STATE OF OREGON
 WATER WELL REPORT
 (as required by ORS 537.785)

September 10, 1991

Subject: Hydrogeologic evaluation of proposed well Spencer #1
located approximately W. 650' & N. 900' from the
SE corner Section 11, T. 30 S., R. 15 W., W.&M.
off Croft Road, Coos County, Oregon

DRAWING #1

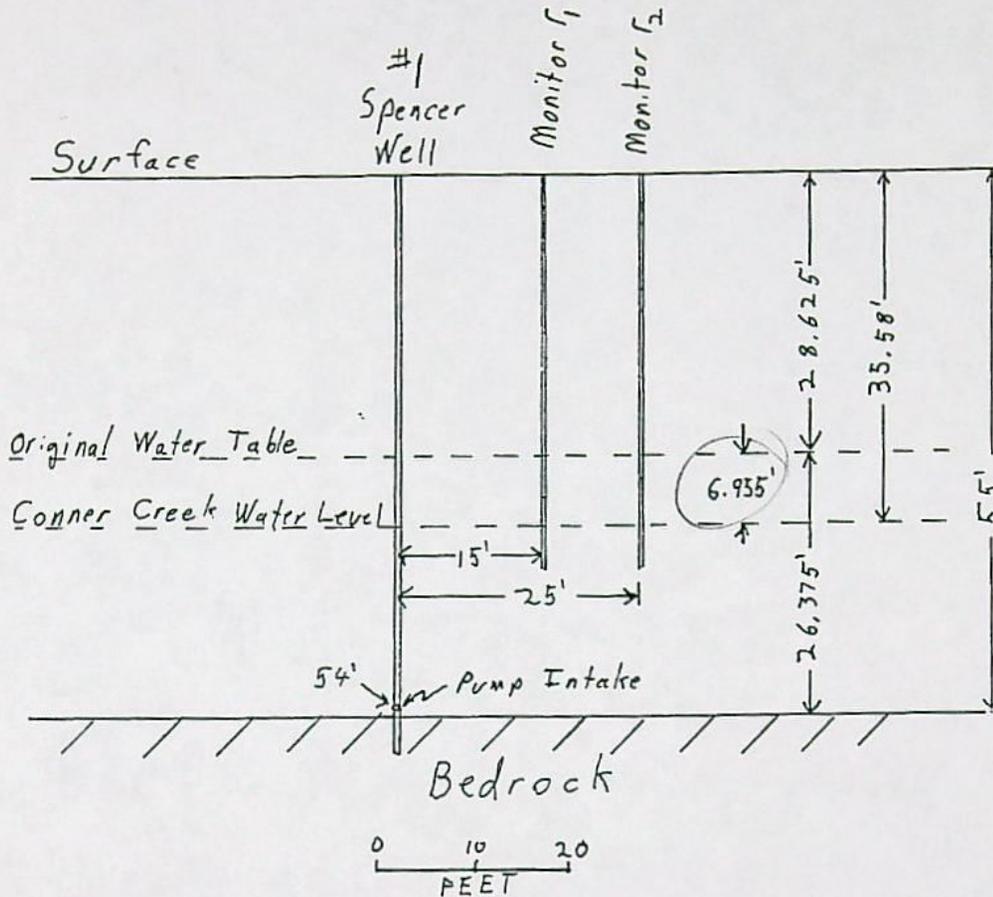
Where does
 5.58' come
 from?
